Subject: AP1000 Response to Request for Additional Information (SRP 9)

AP1000 TECHNICAL REPORT REVIEW

RAI Response Number: RAI-TR44-01
Revision: 1

The changes associated with the revised approach to handle new fuel assembly drop accidents are reflected in changes to Section 2.8.5 of the attached draft version of non-proprietary calculation APP-GW-GLR-026, Revision 4, July 2010, New Fuel Storage Rack Structural/Seismic Analysis, (Technical Report Number 44, TR44)

Figure 2-10 — Baseplate Deformation Resulting from Fuel Assembly Drop onto Baseplate

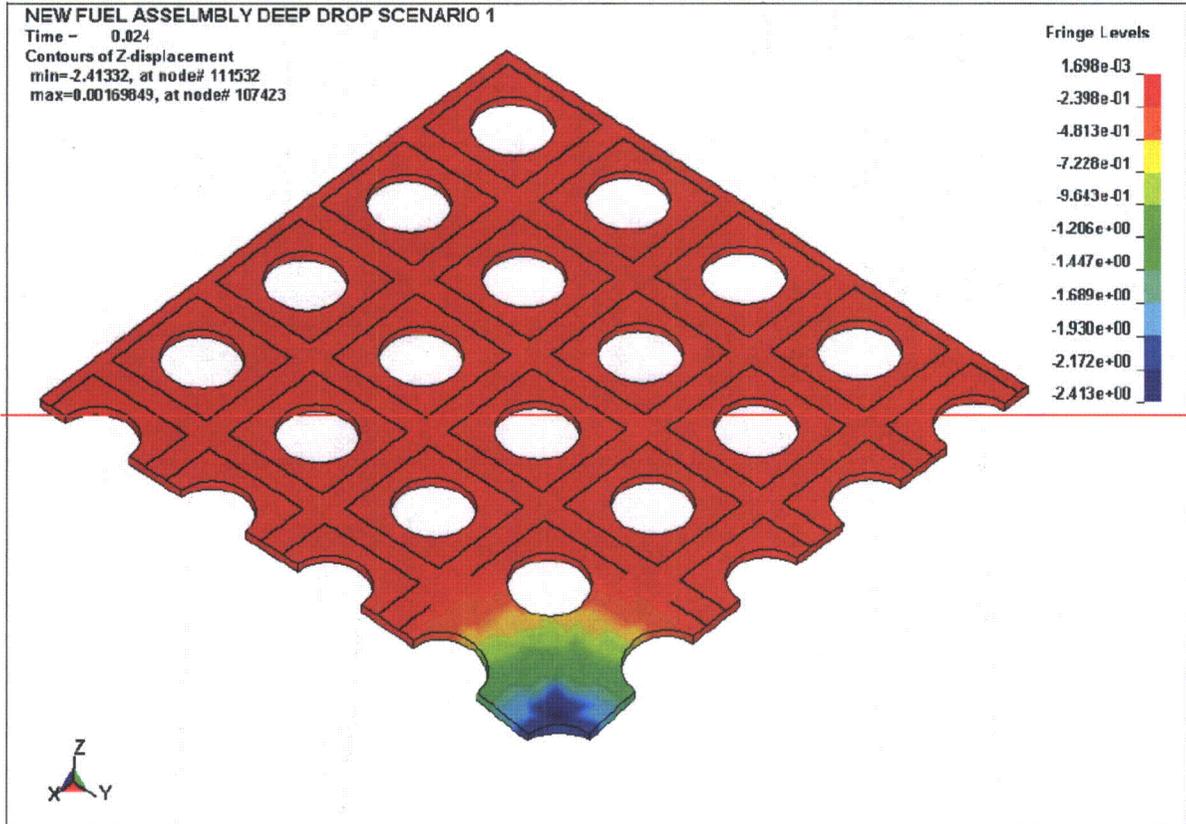
Figure 2-10 of TR44 was revised to reflect the updated results of the drop analysis; see the Technical Report Revision section for details.

~~Yes~~ Figure 2-10 was replaced by the following figure:

The next revision of TR44 will remove all detailed discussions, tables, and figures that reference applicability of the new fuel assembly drop accident scenarios.

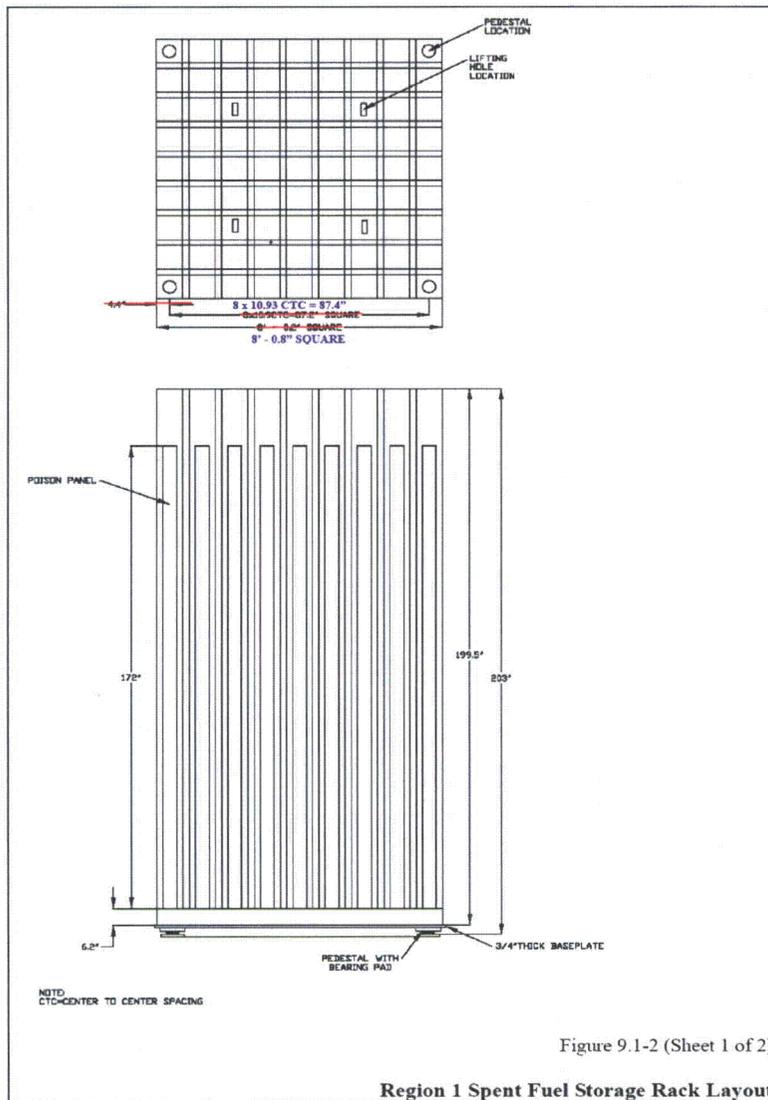
- Figure 9.1-2 (Sheet 1 of 2) of Rev. 17 of the DCD should be modified as follows:
 - The 4.4" dimension should be deleted, as it can be calculated from the other 2 dimensions provided, and it is inconsistent with the format of Figure 9.1-3.
 - 8x10.9CTC=87.2" SQUARE should be changed to 8 x 10.93 CTC = 87.4" SQUARE
 - 8' - 0.2" SQUARE should be changed to 8' - 0.8" SQUARE

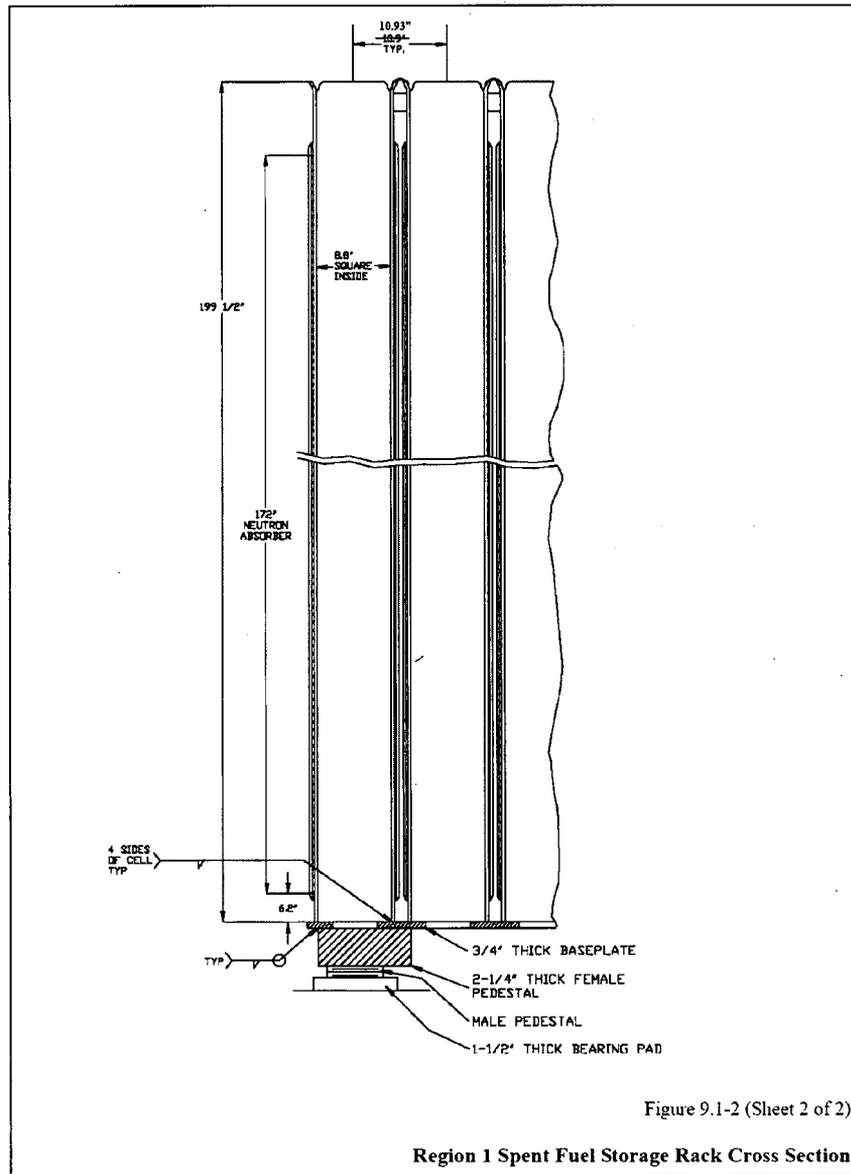
- Figure 9.1-2 (Sheet 2 of 2) of Rev. 17 of the DCD should be modified as follows:
 - 10.9" TYP. should be changed to 10.93" TYP.

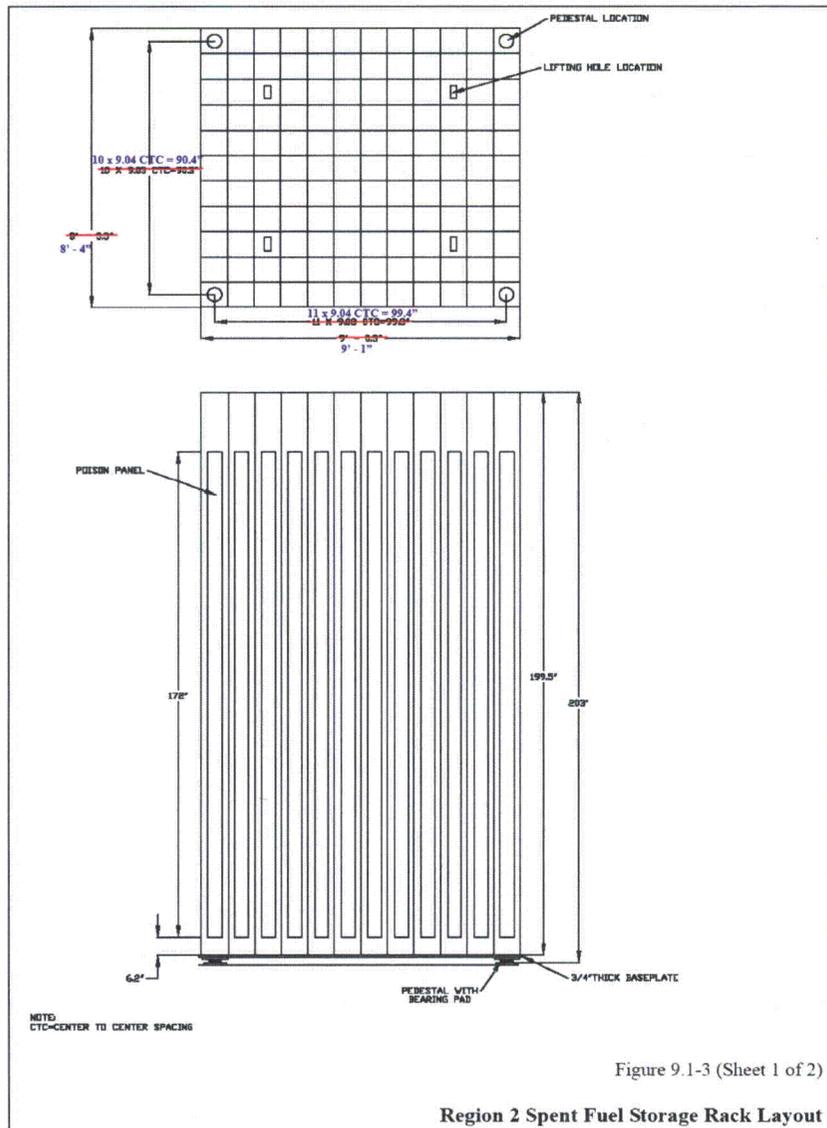
- Figure 9.1-3 (Sheet 1 of 2) of Rev. 17 of the DCD should be modified as follows:
 - 10 x 9.03 CTC=90.3" should be changed to 10 x 9.04 CTC = 90.4"
 - 8' - 3.3" should be changed to 8' - 4"
 - 11 x 9.03 CTC=99.3" should be changed to 11 x 9.04 CTC = 99.4"
 - 9' - 0.3" should be changed to 9' - 1"

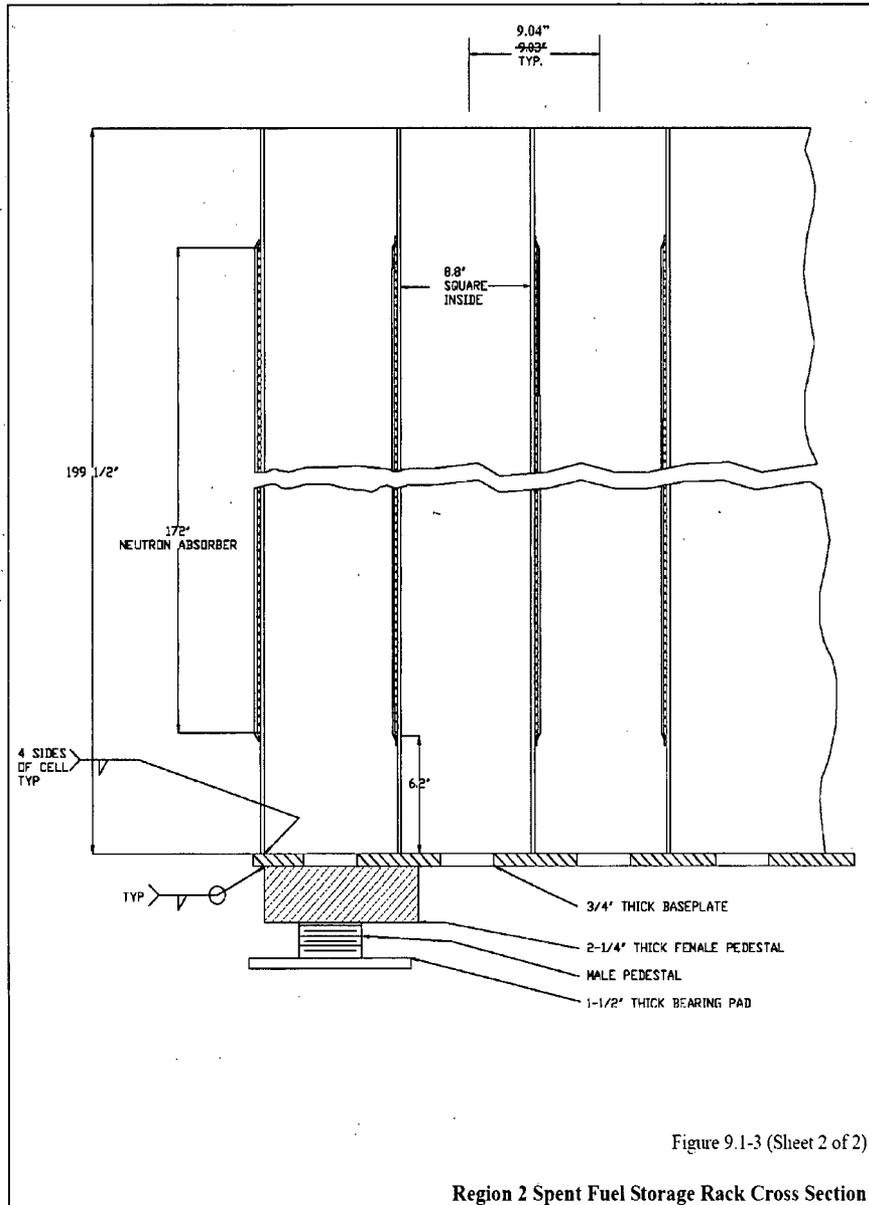
- Figure 9.1-3 (Sheet 2 of 2) of Rev. 17 of the DCD should be modified as follows:
 - 9.03" TYP. should be changed to 9.04" TYP.

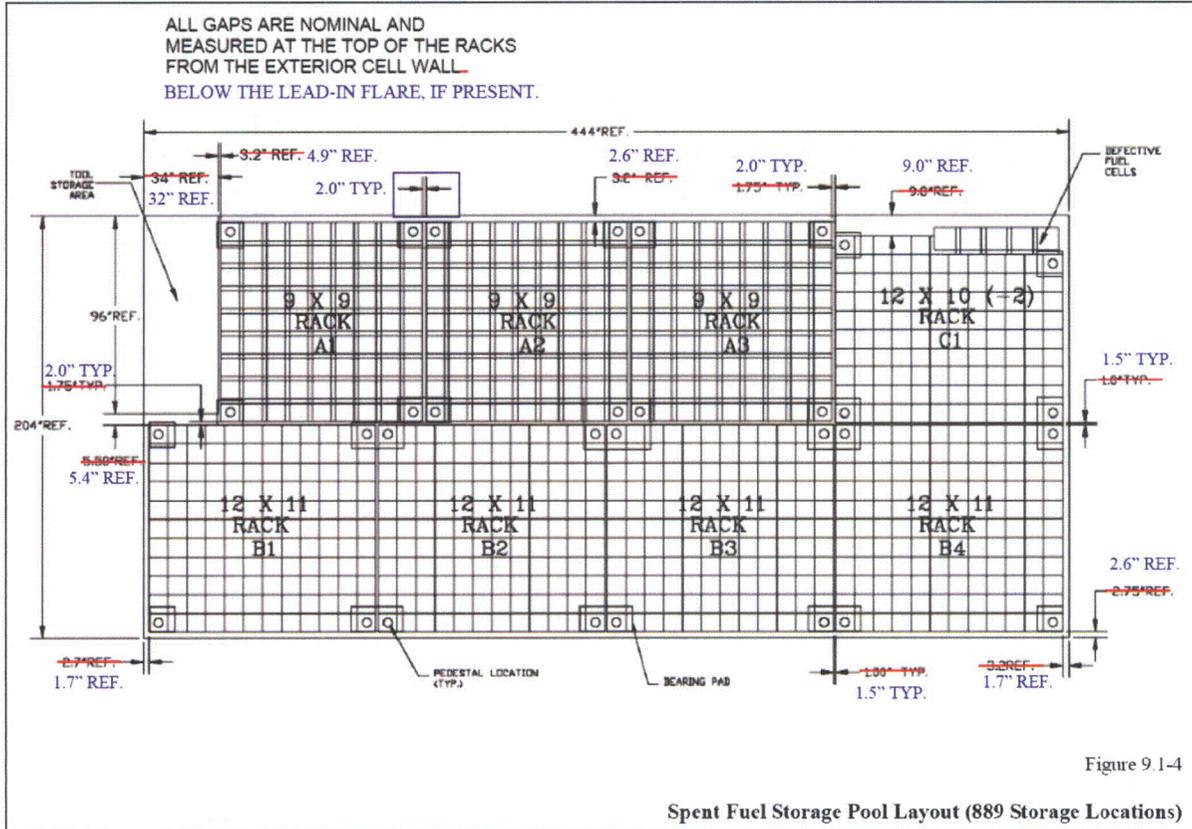
- The placement of the racks within the spent fuel pool is being modified to account for the aforementioned changes and to optimize the gaps such that the impacts (both rack-to-rack and rack-to-wall) are minimized. The slightly modified pool layout is shown in the markup of DCD Figure 9.1-4 on the following page.

- Figure 9.1-4 and Technical Specification Figure 4.3-1 of Rev. 17 of the DCD should both be modified as follows:
 - Details are included in the marked-up figure.
 - (Note that a previous Westinghouse approved design change modified this figure to change the 34" tool storage area and corresponding 3.2" gap to Rack A1 to 33" with a 4.2" gap.) These dimensions are now changed to make the tool storage area width 32" and the gap to Rack A1 distance 4.9".
